Access Compliance Report

Public Rights-of-Way

| Intersection ID: 29271 | Main Street: IRON_BRIGADE_LN | Cross Street: LAKOTA_CT | Location: E |
| ADA ID: 69BC42D3D7D6 | Ramp Type: Perp | Initial Pass/Fail: Fail | Overall Compliance: No |

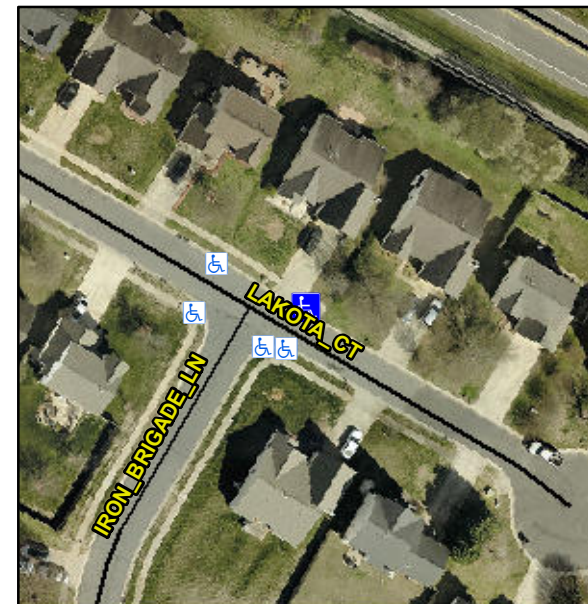
R304.2.2, R304.5.3

| Compliance | Description | Data | Compliance | Description | Data |
|------------|-----------------------|-------|------------|-----------------------------|------|
| N/A | Ramp Length (in) | 48.0 | No | Ramp Slope (%) | 12.0 |
| Yes | Ramp Width (in) | 48.0 | No | Ramp XSlope (%) | 3.3 |

Remove & Replace Entire Ramp.
